### REMARKS

Claims 16-30 replace claims 1-15.

FIG 1

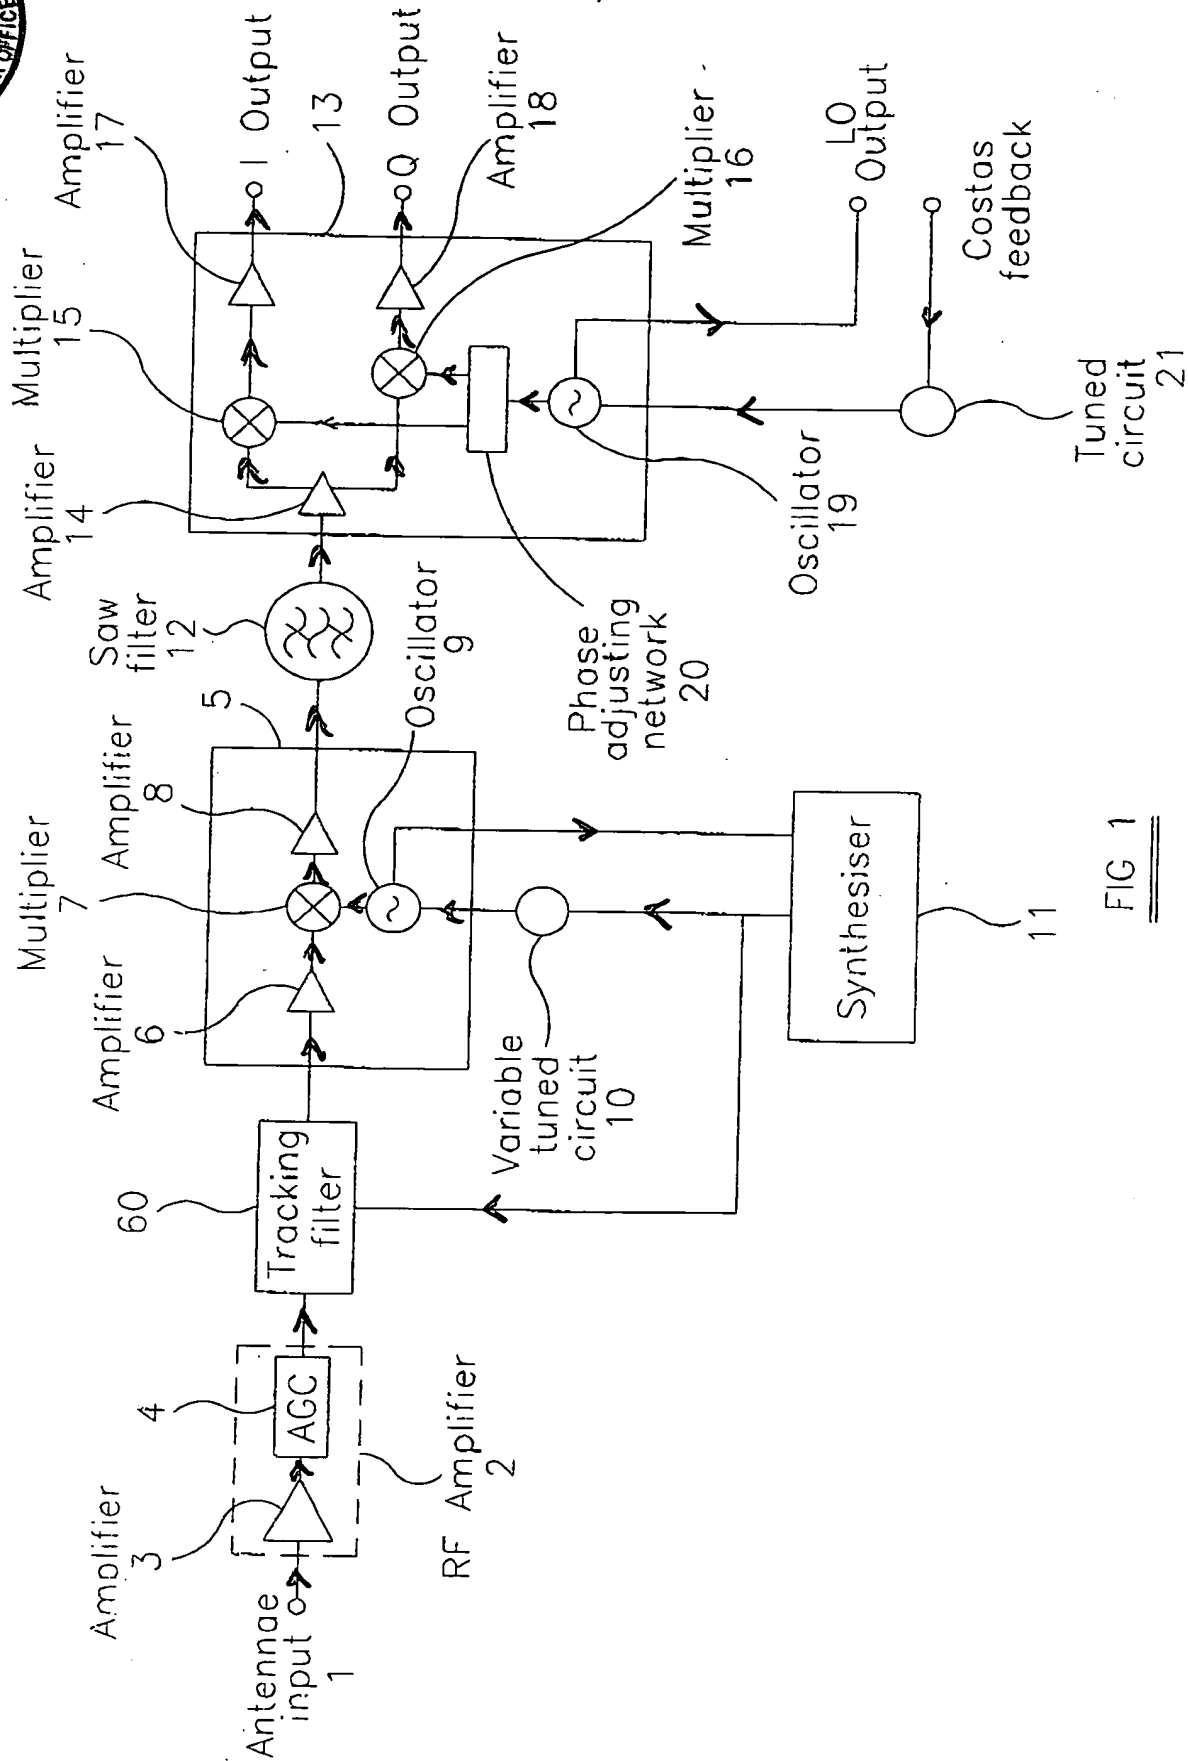
The amended Figs. 1-5 in the Appendix include arrows depicting signal flow as well as the legend "*Prior Art*" for Figs. 102, as required.
